Wizards Workshop

Published by Service Admin Support
56-037

March 6, 1981
Issue 11-4

618 MOD DM, GMA125 MOD KA POWER SUPPLY CABLE

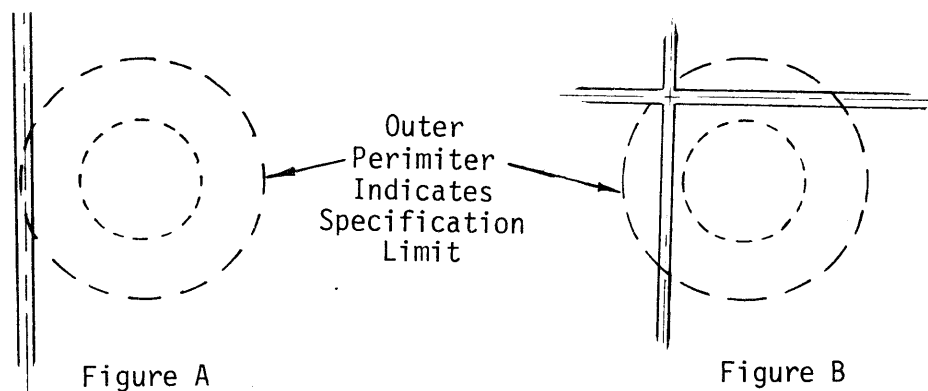
Factory Service has received power supplies (P/N 620-0279-00) from the field with power cable attached. Cable is installed from J25 in power supply to Molex connector on back panel of display. Cable P/N is 175-2674-00. This cable is NOT part of the 620-0279-00 power supply and should be removed (and left with instrument) before shipping power supply to Factory Service for exchange.

Section 2 Specification
Pages 2 - 5
Signals Out Vert. Sig. Out Centering Supplemental Information.

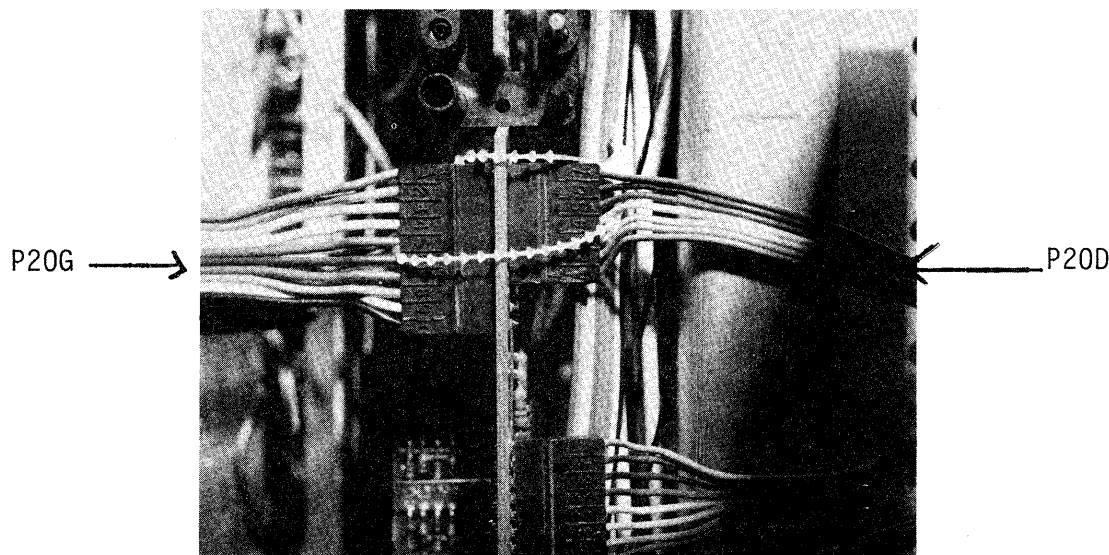
7603 AND 7613 VERT. SIG. OUT CENTERING SPEC. CORRECTION

Text Changes

Change to read:
+3 div system CRT to VERT SIG OUT. (1.5V into 1M Ω or 75mV
into 50 Ω .)

DIAGRAM 15 Digital Storage Vertical - Partial

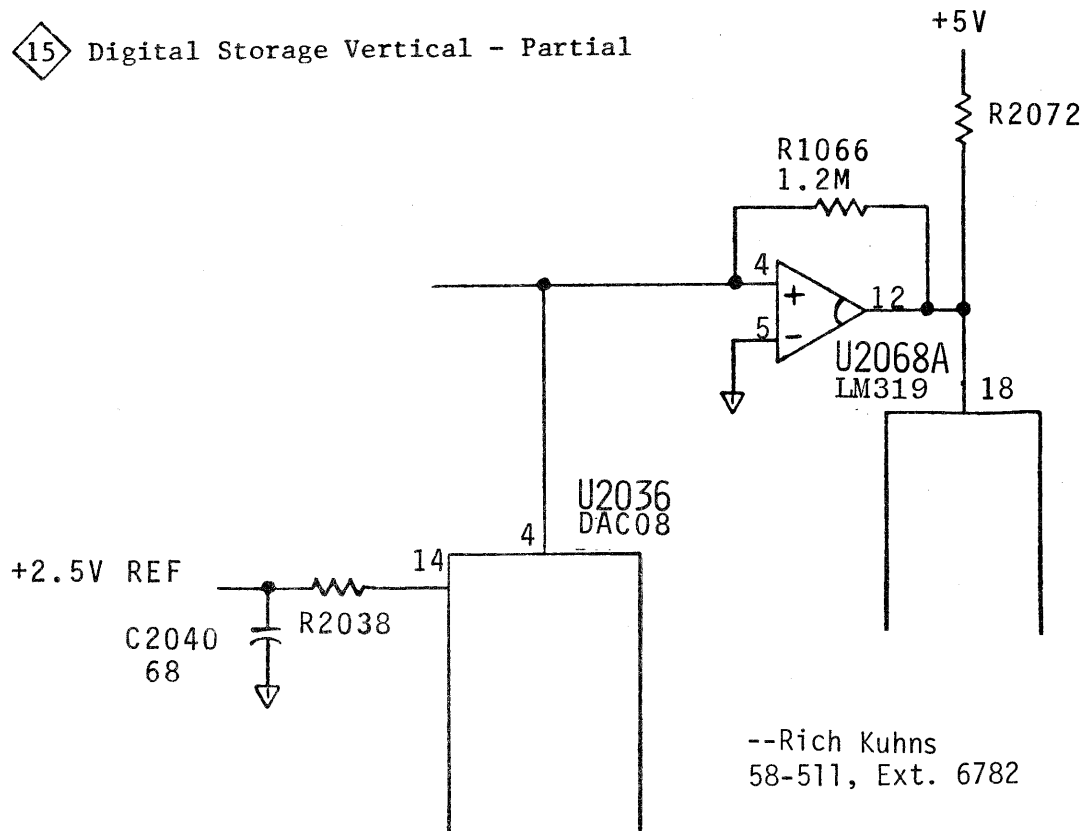
7L14 MANUAL CORRECTIONS TO DIAGRAM 15

The following is a list of corrections to the 7L14 manual P/N 070-3434-00.

CHANGE TO:

A88R3080 321-0411-00 RES., FXD, FILM: 187K OHM, 1%, 0.125W

REMOVE:

A88R2074 315-0102-00 RES., FXD, CMPSN: 1K OHM, 5%, 0.25W

A88R2093 315-0180-00 RES., FXD, CMPSN: 18 OHM, 5%, 0.25W

A88R3091 315-0180-00 RES., FXD, CMPSN: 18 OHM, 5%, 0.25W

ADD:

A88C2040 290-0530-00 CAP., FXD, ELCTLT: 68UF, 20%, 6V

A88R1066 315-0125-00 RES., FXD, CMPSN: 1.2M OHM, 5%, 0.25W

A88W2093 WIRE STRAP, #22

A88W3091 WIRE STRAP, #22

CF-1 Current Source Circuit Board Assembly 670-3722-03

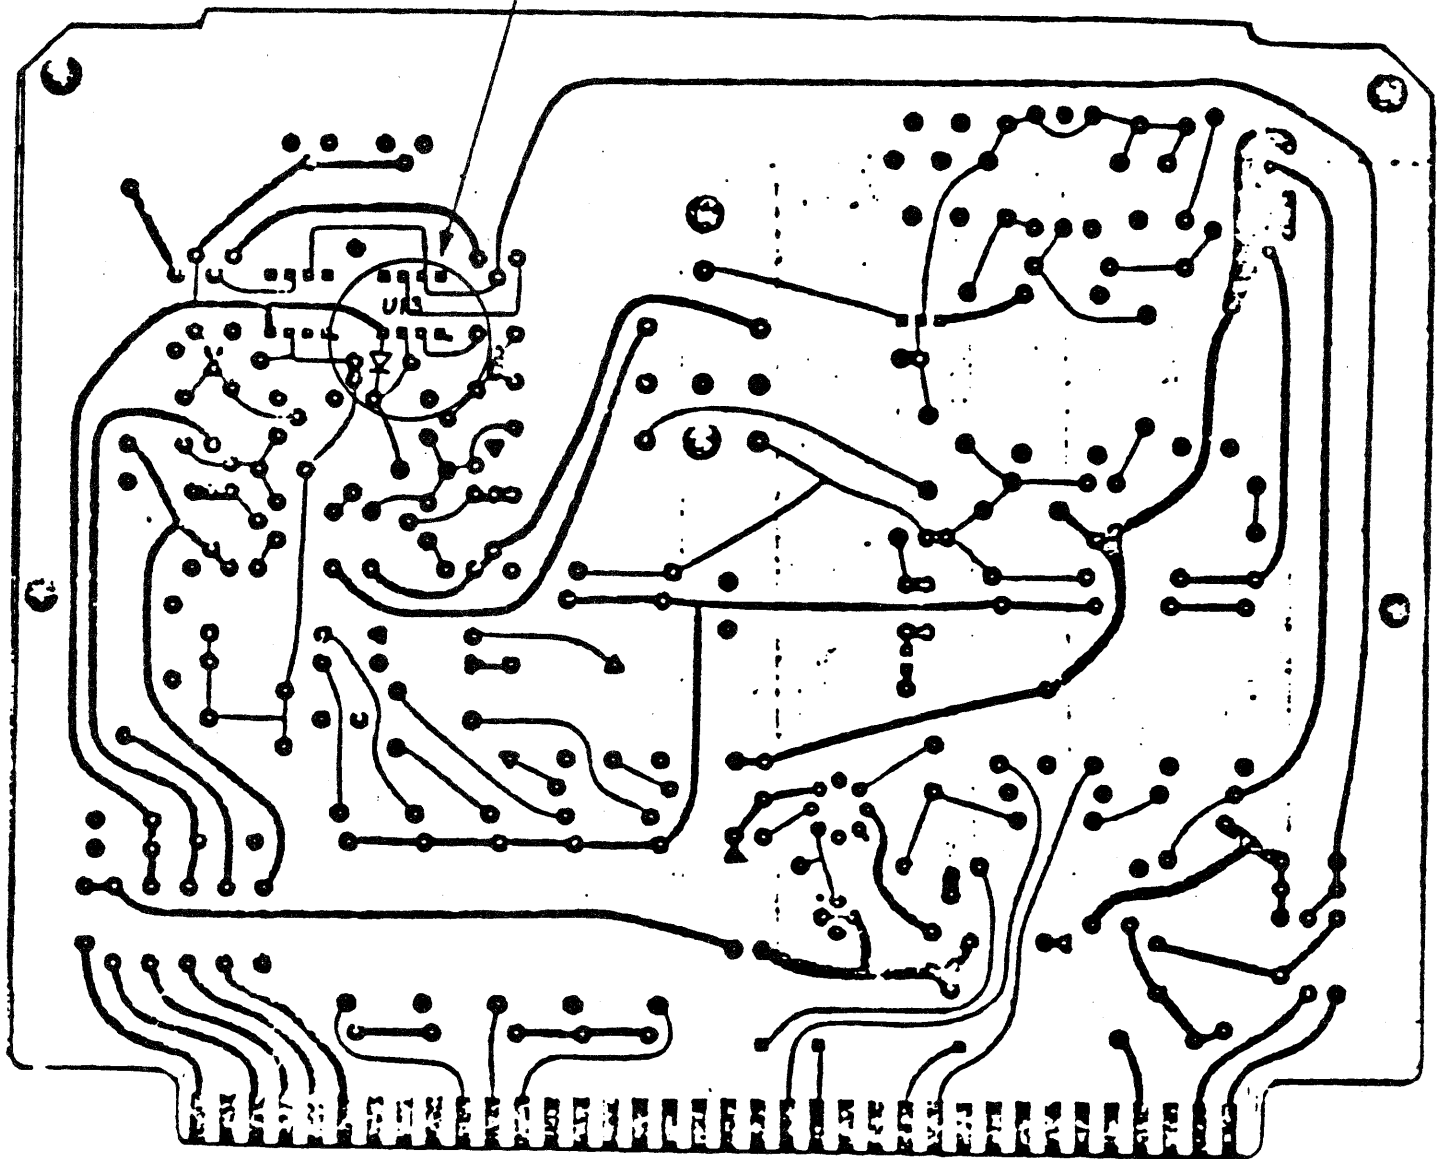
The CF1 Option is part of the S3200 series Systems Test Stations. Upon test station power-up, integrated circuits on CF1 Current Source Circuit Board are latched up due to negative voltage on the non-inverting input of U13.

The addition of CR237 Semiconductor Device Diode (152-0323-00) from U13 pin three to ground on CF1 current source circuit board assembly will clamp the input of U13, preventing it from going more negative than -1V.

ADD: CR237 1 ea. 152-0323-00 Semicond. DVC DI SW, SI, 35V, 0.1A, SE365

Add CR237 152-G323-00
from U13 pin 3 to ground.

670-4152-02
(MC3 TEST FIXTURE)

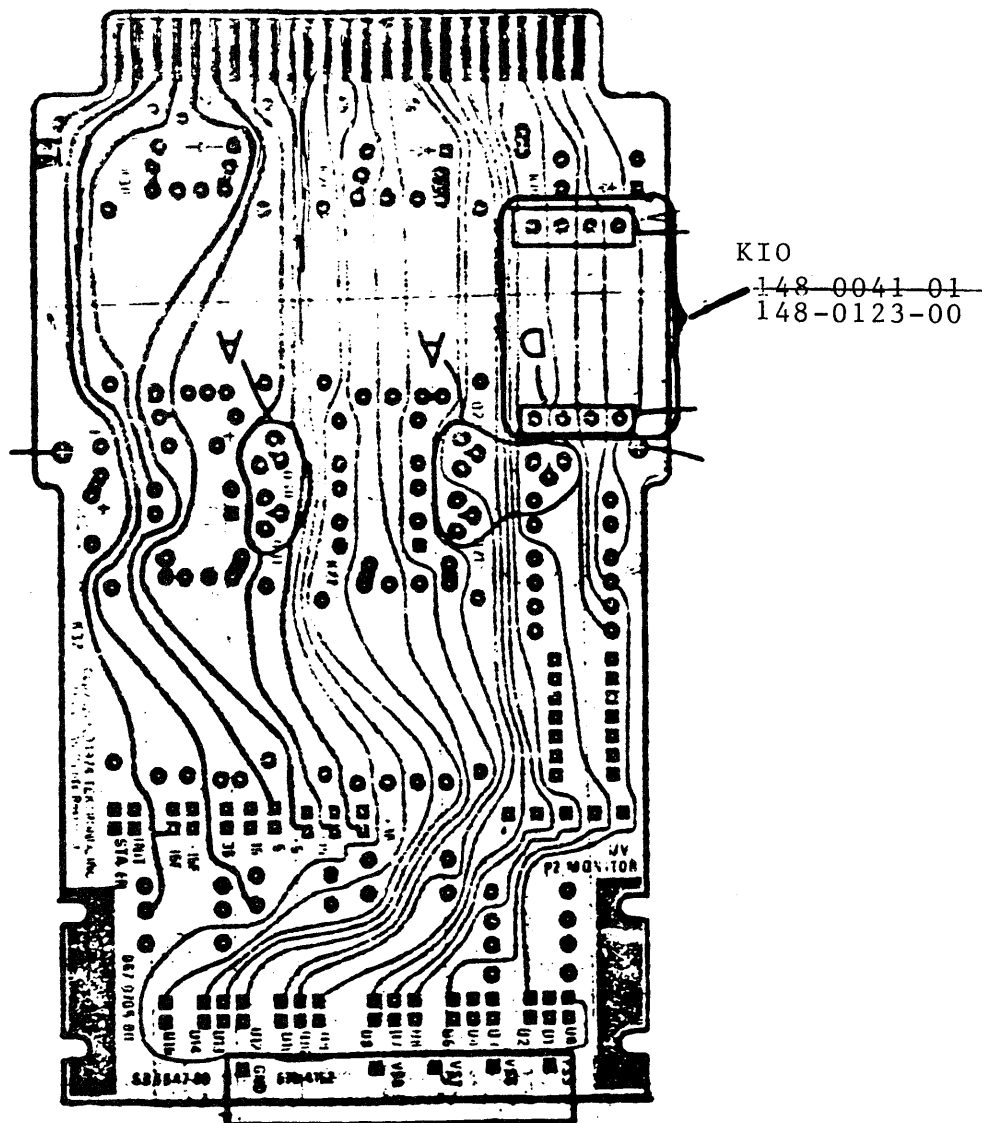
The MC-3 Test Fixture Assembly 670-4152-01 is changed to provide greater reliability. Reliability is improved by removal of all sockets and replacement of K10.

K10 (148-0041-01) is replaced by 148-0123-00, Reed Relay. The sockets for K10 must be removed prior to soldering in the new K10 Reed Relay.

REMOVE ALL SOCKETS AND SOLDER
DIRECTLY INTO CIRCUIT BOARD.

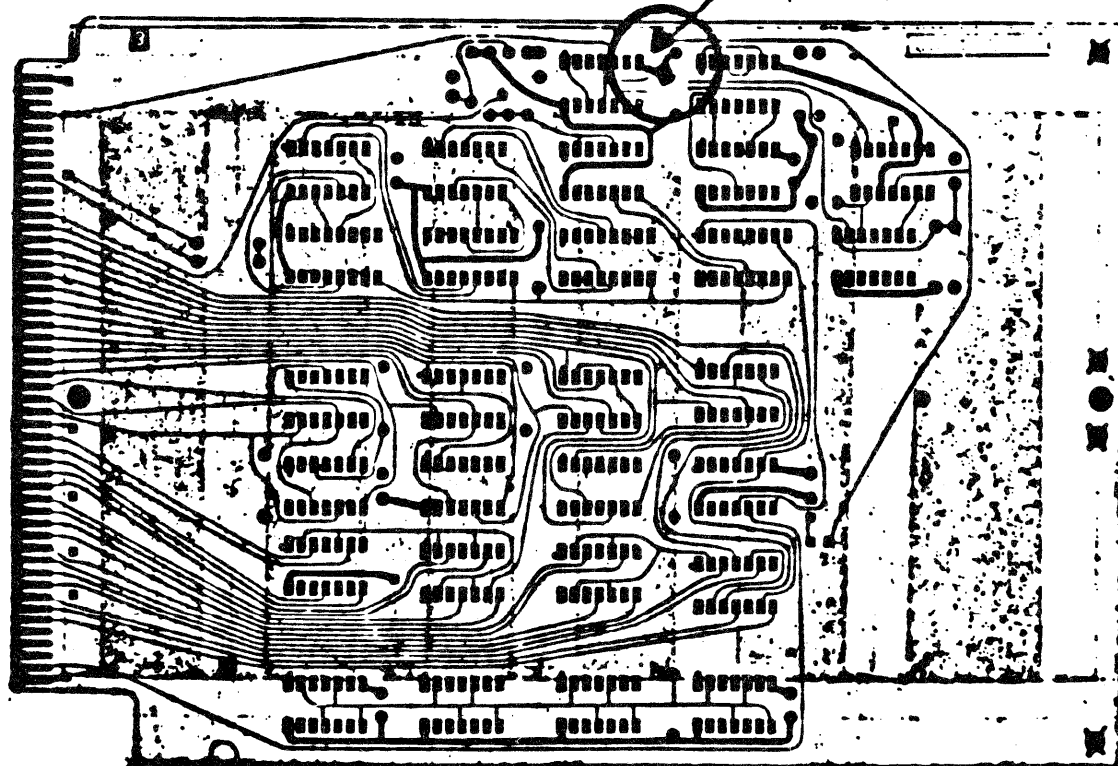
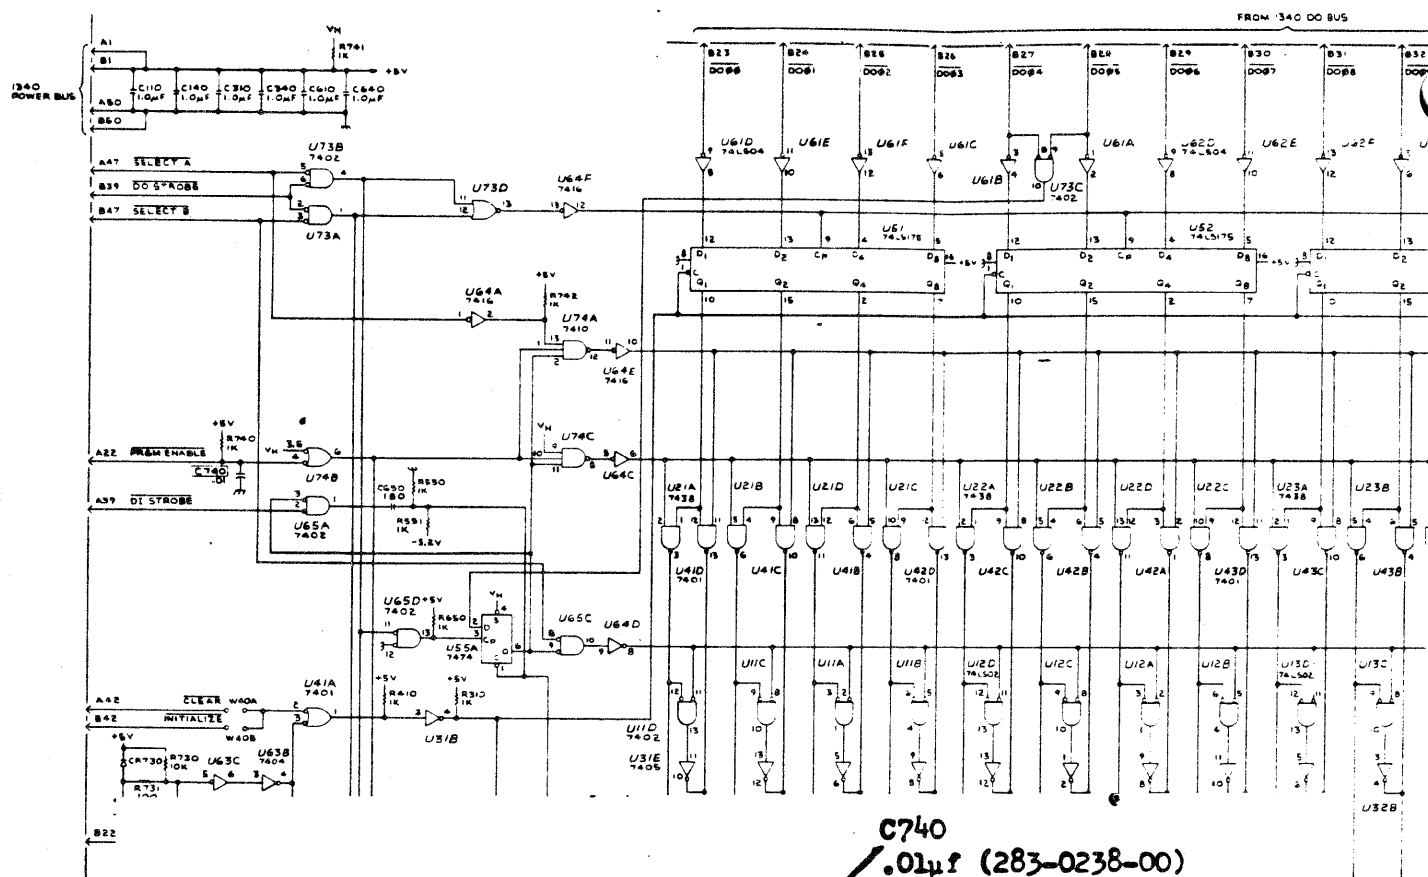
Cross talk noise in the R2942 Pattern Generator creates intermittent and random errors. The noise generated at the input of U47B, Pin 4 can be reduced with the addition of C740.

Install C740 (283-0238-00) on the dip side of the 2942 Interface Circuit Card Assembly (670-3674-00). C740 is installed from ground to the "PRGM ENABLE NOT", Pin A22 input line. See attached schematic and dip side layout.

C740 .01 μ F, 10%, 50V.
